STATE OF VERMONT
AGENCY OF TRANSPORTATION

RECORD PLANS

PROPOSED IMPROVEMENT
BRIDGE PROJECT
TOWN OF BENNINGTON
COUNTY OF BENNINGTON
BENMONT AVE. (TH-7) (URBAN MINOR ARTERIAL)
BRIDGE NO. 57

PROJECT NAME : BENNINGTON
PROJECT NUMBER : BRF 1000 (16)

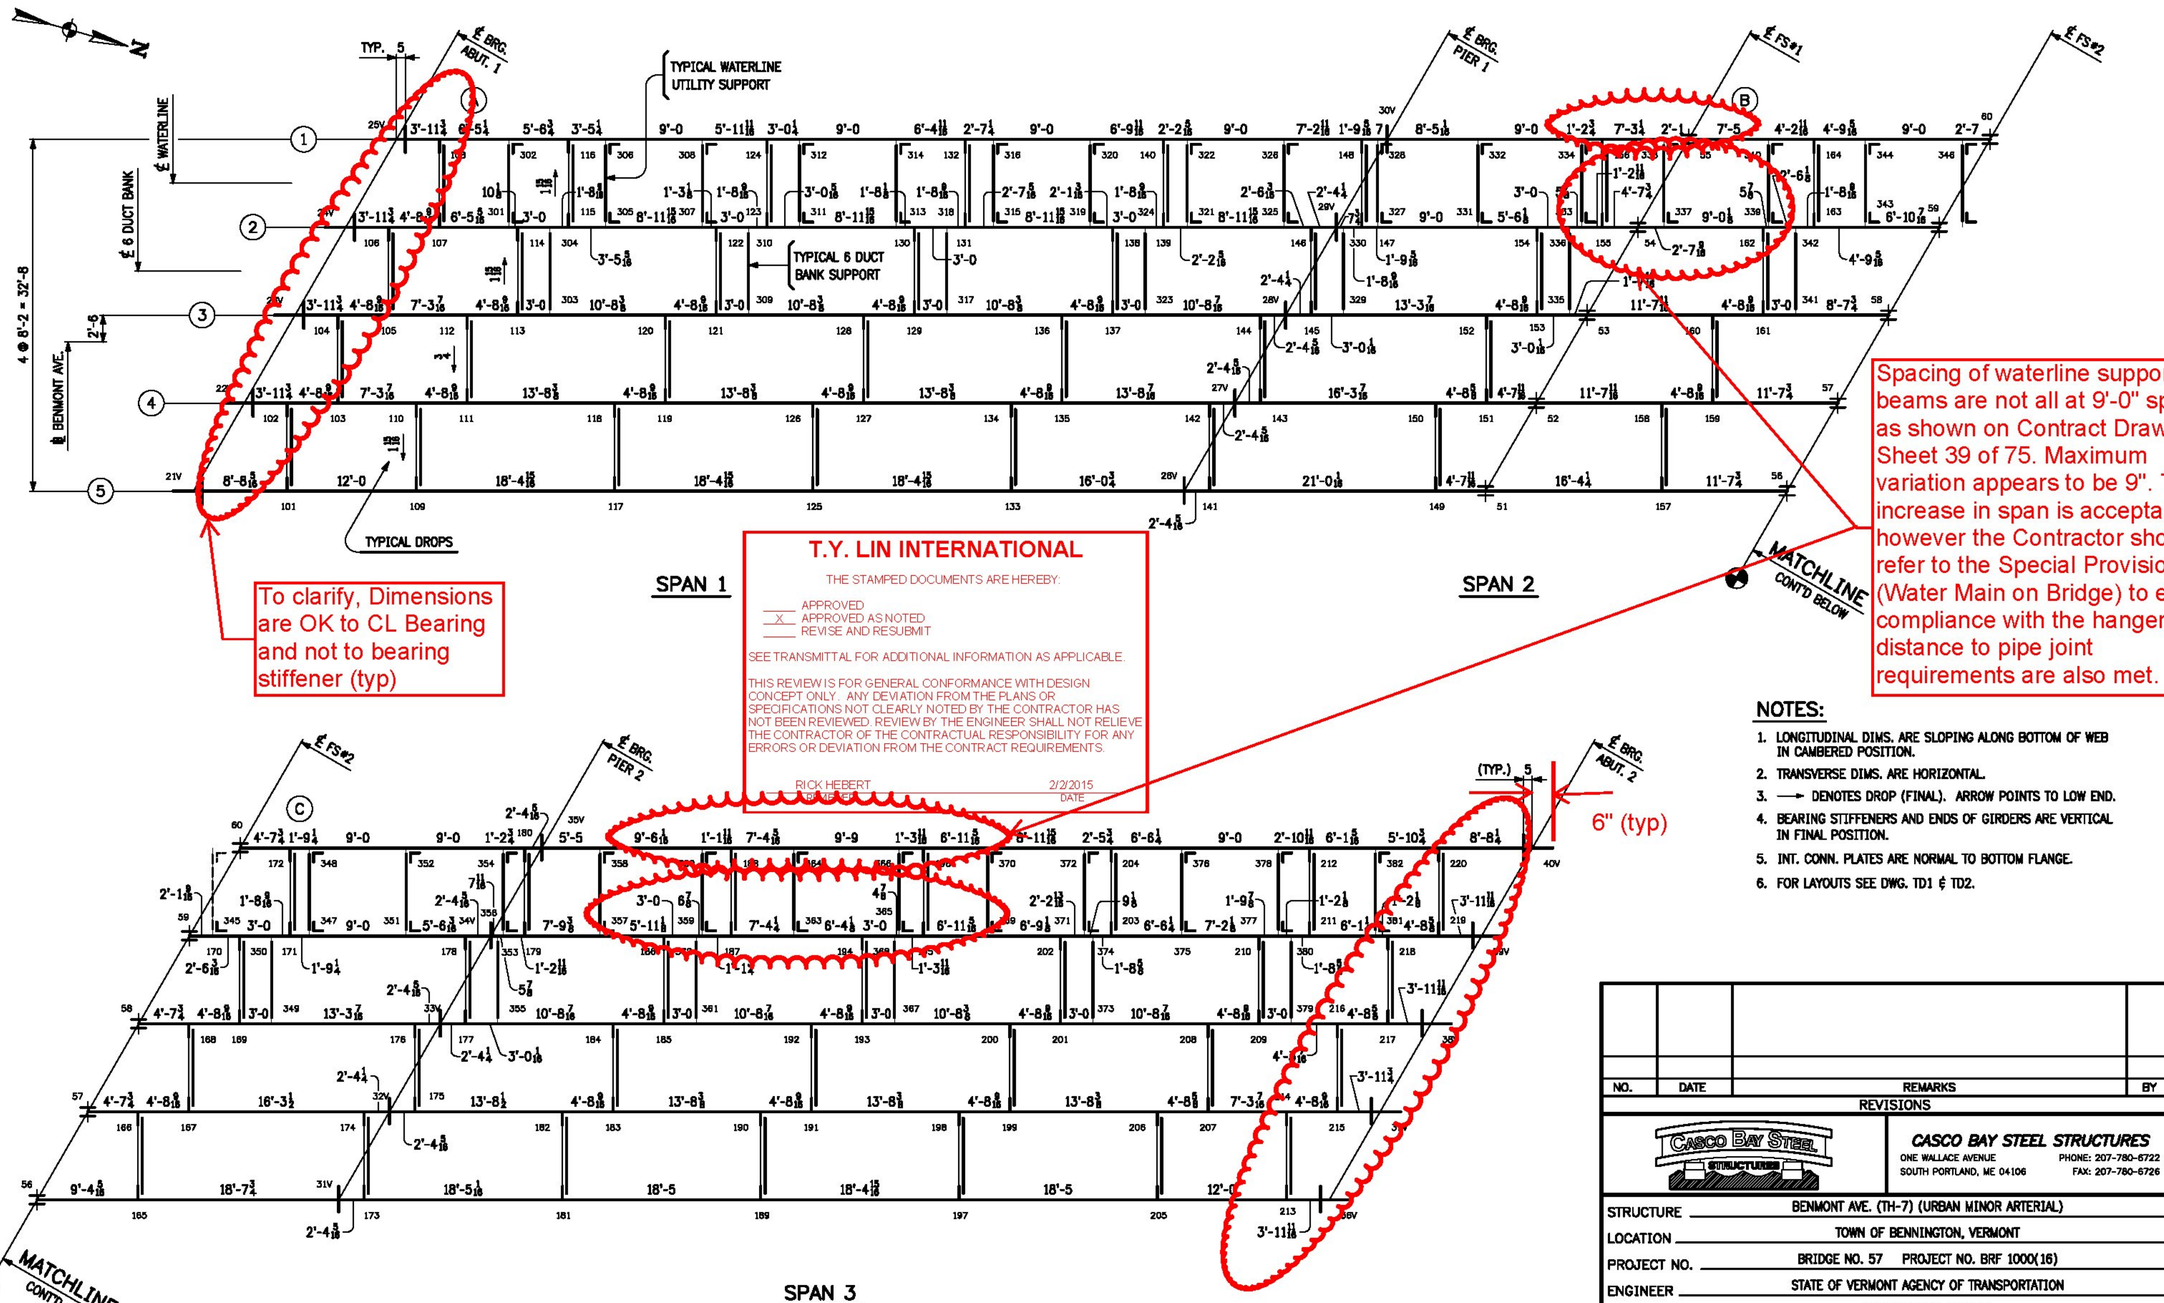
To clarify, Dimensions are OK to CL Bearing and not to bearing stiffener (typ)

Spacing of waterline support beams are not all at 9'-0" spaces as shown on Contract Drawing Sheet 39 of 75. Maximum variation appears to be 9". The increase in span is acceptable, however the Contractor should refer to the Special Provision (Water Main on Bridge) to ensure compliance with the hanger distance to pipe joint requirements are also met.

CAMBER DIAGRAM

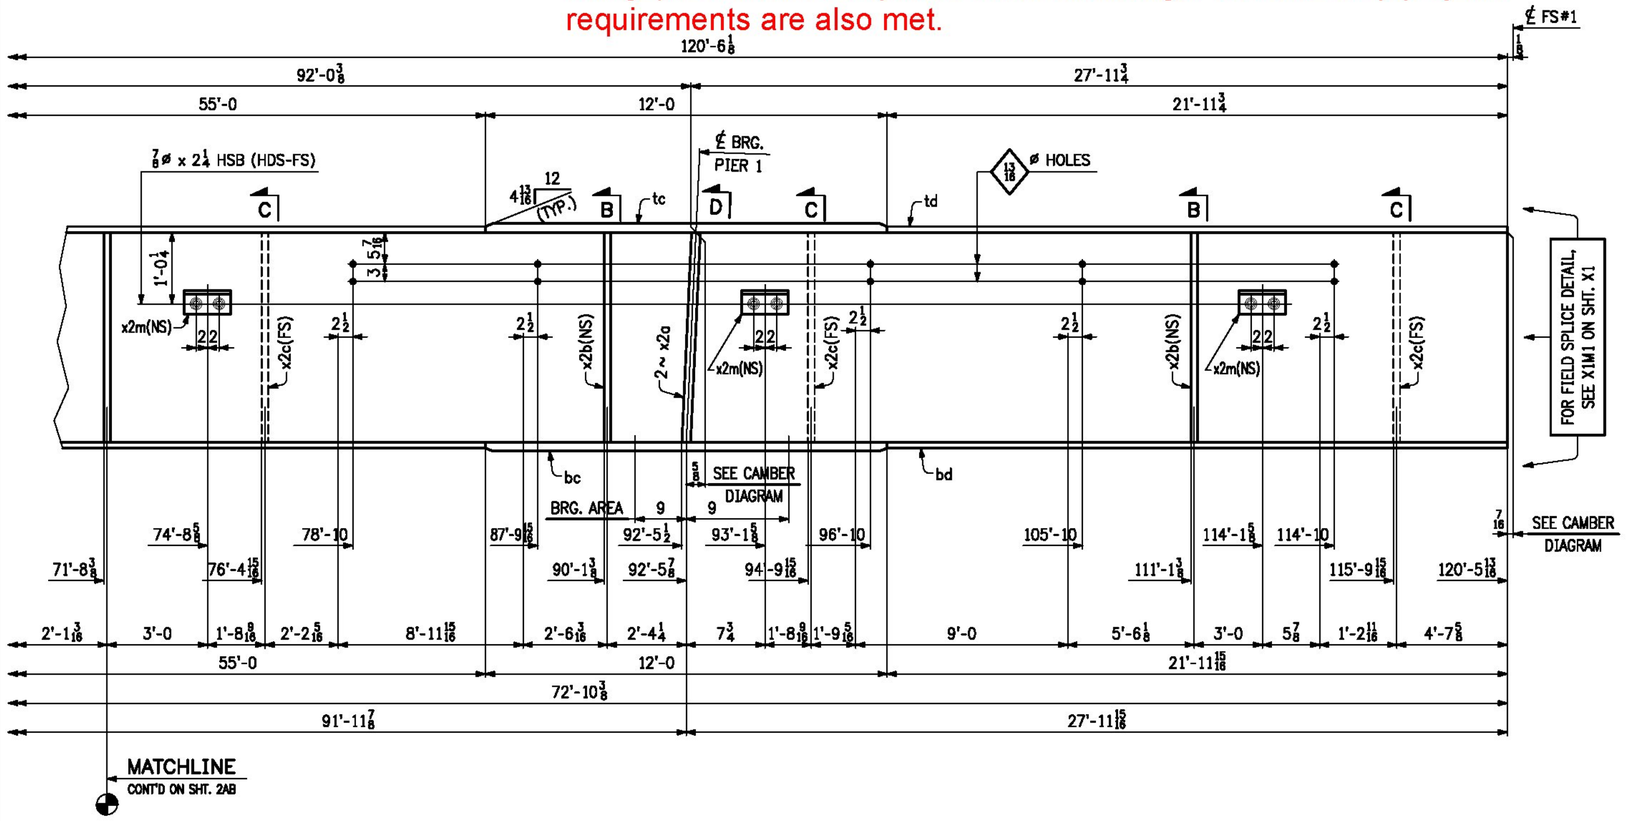
Spacing of waterline support beams are not all at 9'-0" spaces as shown on Contract Drawing Sheet 39 of 75. Maximum variation appears to be 9". The increase in span is acceptable, however the Contractor should refer to the Special Provision (Water Main on Bridge) to ensure compliance with the hanger distance to pipe joint requirements are also met.

ERECTION PLAN

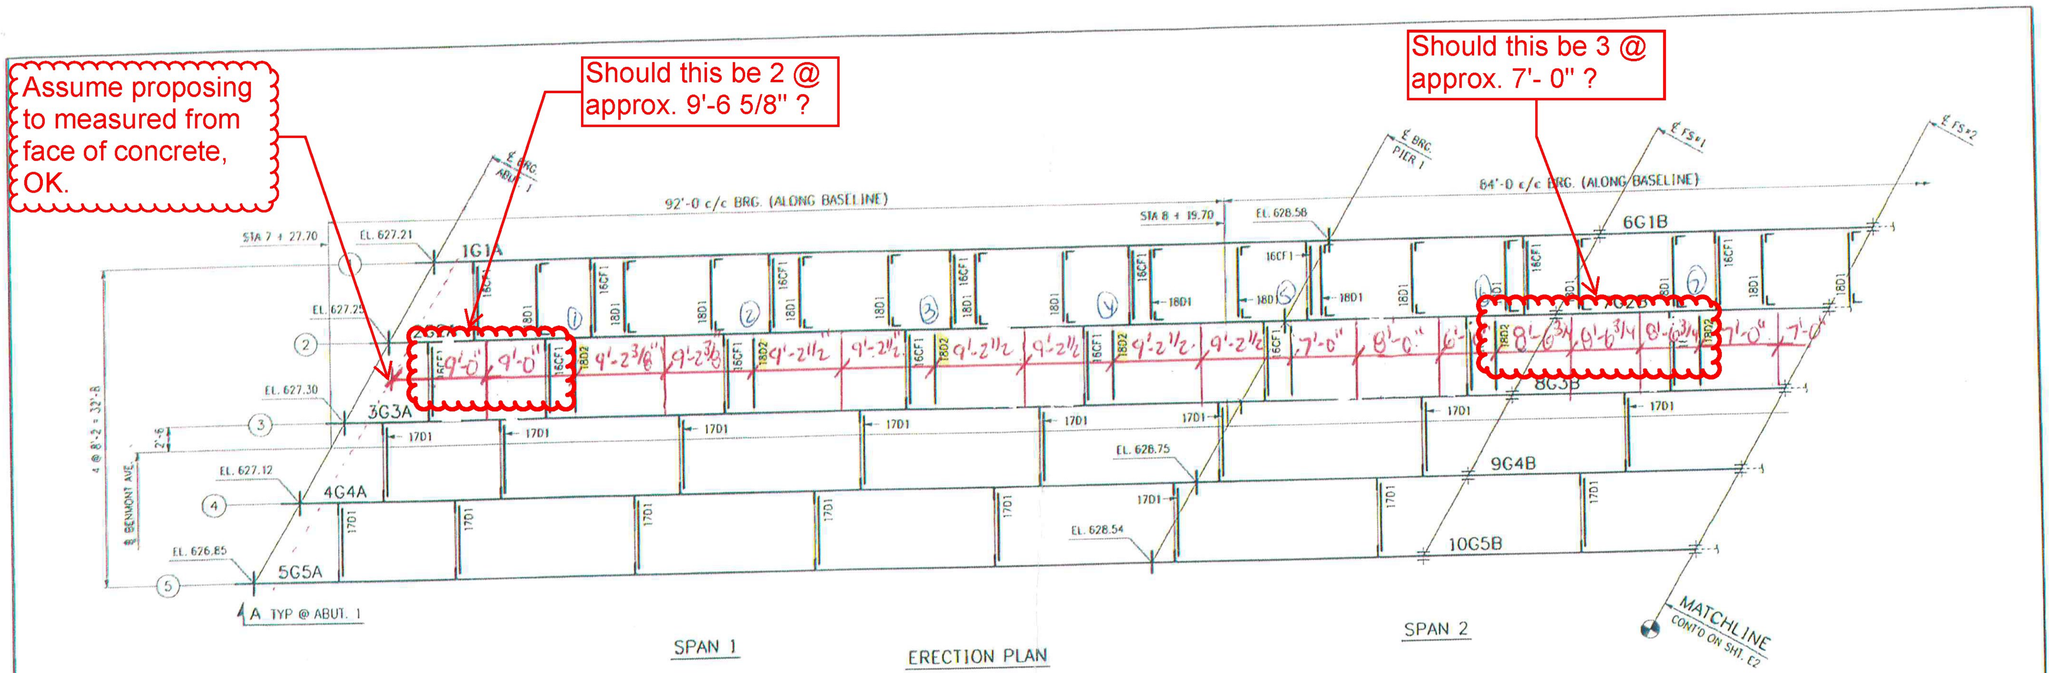
Should this be 3 @ approx. 7'- 0" ?

SPAN 3

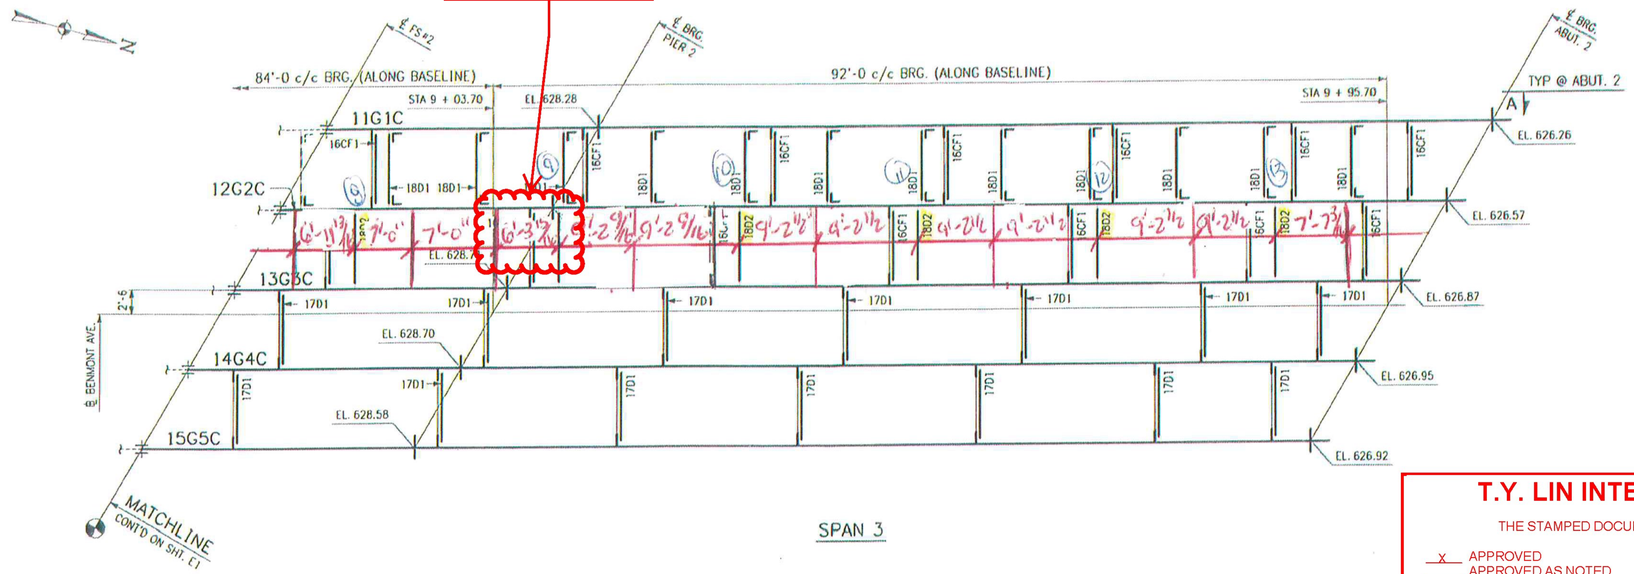
Should this be approx. 7'-0" ?

Ok with general spacings as indicated. Did find some minor discrepancies with summations for spacings in comparison to locations of utility supports shown in approved shop drawings. Just check/verify spacings as noted.
